Subject: Docket No. 50-206  
Effects of Non-Category A Equipment Failure  
San Onofre Nuclear Generating Station  
Unit 1

ENCLOSURE 1

## BOTTOM LAYOUT

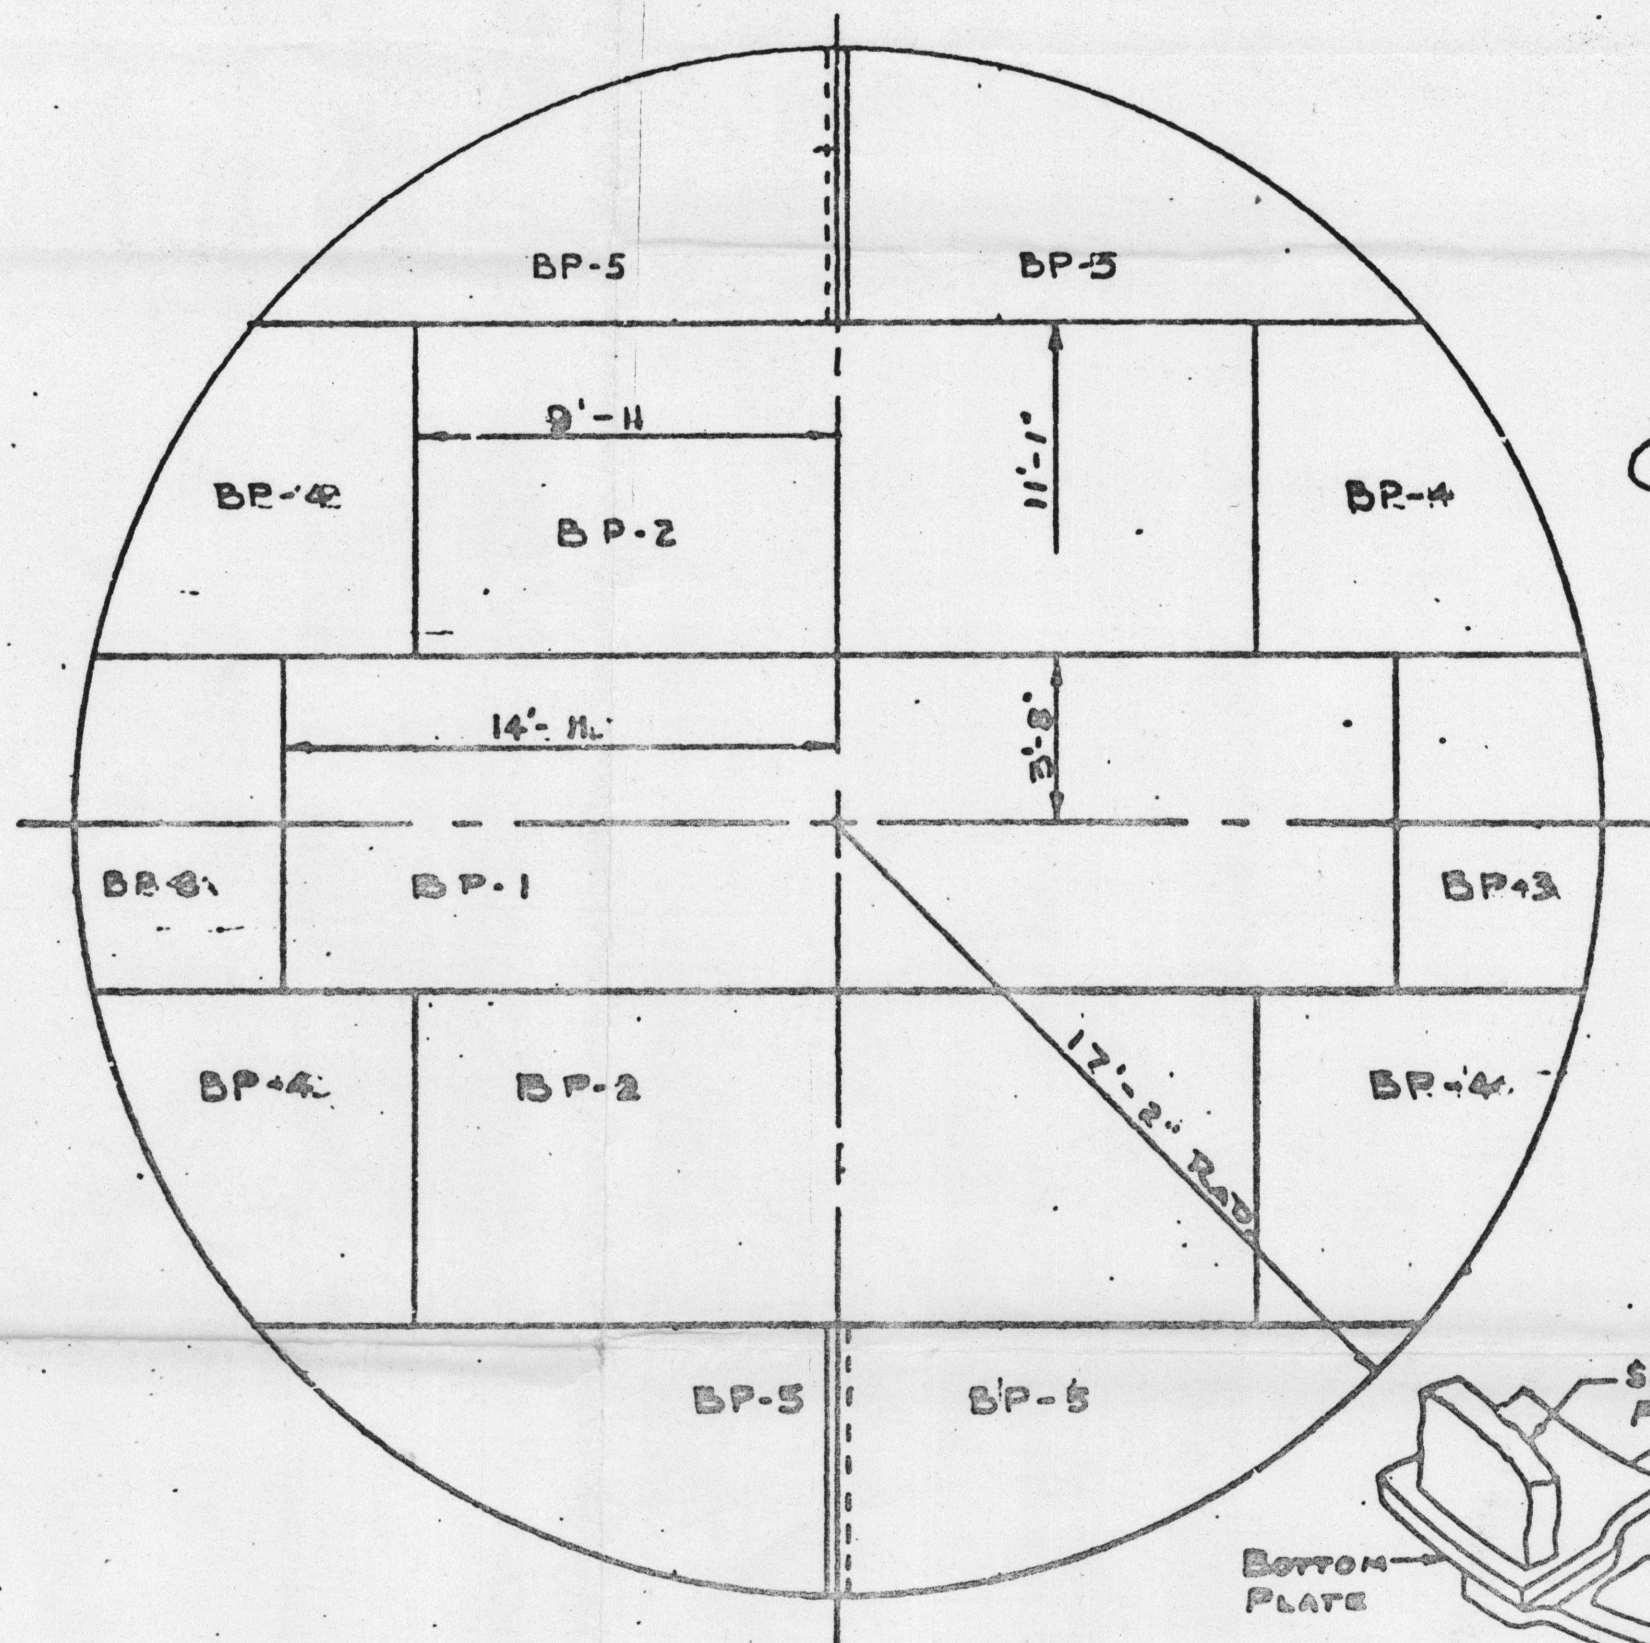
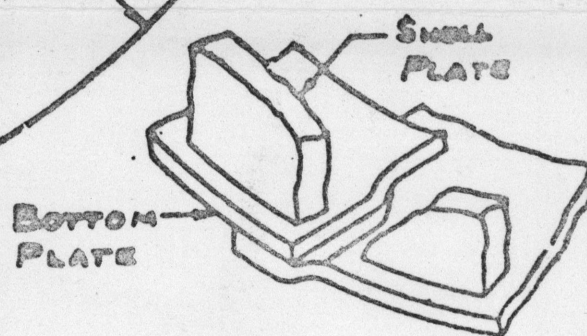
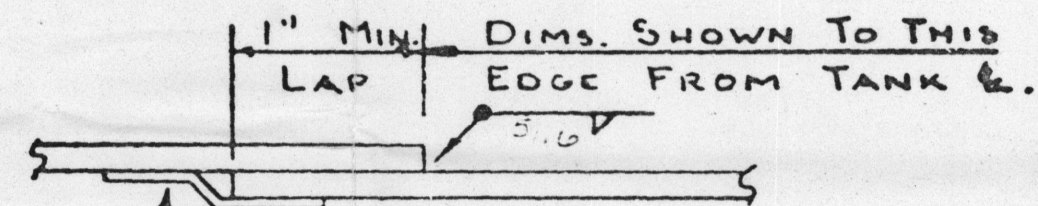
Item 8: Failure of the condensate storage tank could flood safety-related equipment on the +20' and +14' elevation of the turbine building. Describe how this will be mitigated.

Response: Failure of the condensate storage tank (CST) could possibly cause flooding of MCC3, the remote shutdown panel, the uninterruptable power supply (UPS) for MOV-850C and the batteries for the UPS. However, as part of the seismic evaluation of San Onofre Unit 1, the CST is to be analyzed by June, 1981 to determine its seismic capability. Attached are specifications and drawings showing the similarity in design and construction of the CST and the Seismic Category A Refueling Water Storage Tank (RWST). If required, the tank will be upgraded to Seismic Category A following the seismic evaluation. This would remove the CST as a source of flooding for this review.

In the mean time, the door between the turbine building +20' level and the CST will be locked closed during normal plant operation and the air ventilator in the lower portion of the door and the glass window will be blocked off. These steps would minimize flooding in the unlikely event the CST should rupture.

Comparison of the Condensate Storage Tank  
and Refueling Water Storage Tank
